LAND-ROVER SERVICE NEWS LETTER Vol. 2 No. 6

February, 1966

Fig. 1. Rover type pinion housing

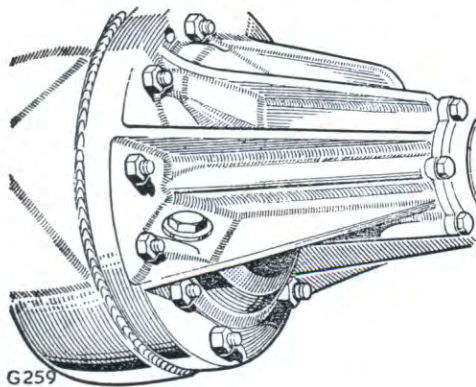
Current Part No.	Location	Superseded Part Nos.	Models	Identification	Overall length	Remarks
556110	RH rear	273385	Series I 109 from axles numbered 121704770 and 131701305 onwards. Optional equipment on 88	EN 24 material Stamped '375' on splined end of shaft	RH shaft $27\frac{7}{32}$ in. (640 mm) LH shaft $34\frac{1}{8}$ in. (866 mm)	
556111	LH rear	273386				
556108	RH rear	276318 507681 512821	Series II and IIA. Up to and including axles with serial suffix letter 'A'	Stamped '375' on splined end of shaft	RH shaft $25\frac{63}{64}$ in. (660 mm) LH shaft $34\frac{55}{64}$ in. (885 mm)	Standard type axle shafts for use with standard type differential unit
556109	LH rear	276319 507681 512822				
549495	RH rear	522568 533775 539736	Series IIA basic models from axle serial suffix letter 'B' onwards and all Forward Control models with Rover type axle	EN 24 material Stamped '415' on splined end of shaft Outer end of shaft threaded	RH shaft $25\frac{63}{64}$ in. (660 mm) LH shaft $34\frac{55}{64}$ in. (885 mm)	25% strengthened axle shafts for use with 35% strengthened differential unit. For identification of Rover and ENV axles see illustration below

549496	LH rear	522569 533776 539737				
533579	RH rear	—	Forward Control with ENV axles	Circlip groove on outer end of shaft	RH shaft $26\frac{9}{16}$ in. (674 mm) LH shaft $32\frac{1}{8}$ in. (736 mm)	For identification of Rover and ENV axles see illustration below
533580	LH rear	—
